## Stroud District Local Plan Review: Draft Local Plan

Subject: Stroud District Local Plan Review

Network Rail would like to make comment on the Stroud District Local Plan Review, Emerging Strategy Paper. This email forms the basis of our response.

This is particularly relevant for potential sites PS19 a) and b) for up to 650 dwellings, open space and 5 ha of employment which is located close to 4 level crossings.

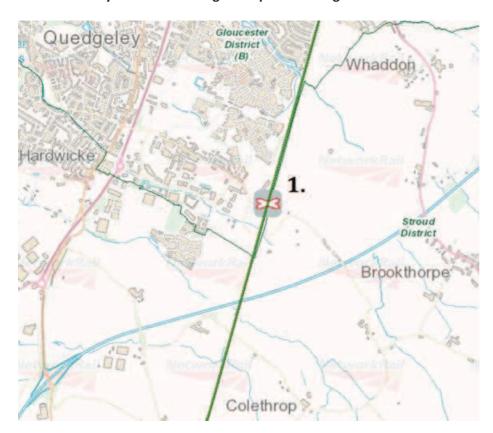
It is Network Rail's and indeed the Office of Rail Regulation's (ORR) policy to reduce risk at level crossings not to increase risk as could be the case with an increase in usage at the three level crossings in question. The Office of Rail Regulators, in their policy, hold Network Rail accountable under the Management of Health and Safety at Work Regulations 1999, and that risk control should, where practicable, be achieved through the elimination of level crossings in favour of bridges or diversions.

The Council have a statutory responsibility under planning legislation to consult the statutory rail undertaker where a proposal for development is likely to result in a material increase in the rail volume or a material change in the character of traffic using a level crossing over a railway.

- 1. Stagholt Level Crossing Footpath Crossing
- 2. Stonehouse 2 Level Crossing Foothpath Crossing
- 3. Little Australia Level Crossing Foothpath Crossing
- 4. Old Ends Level Crossing Vehicular crossing, Manually controlled barriers with closed circuit TV
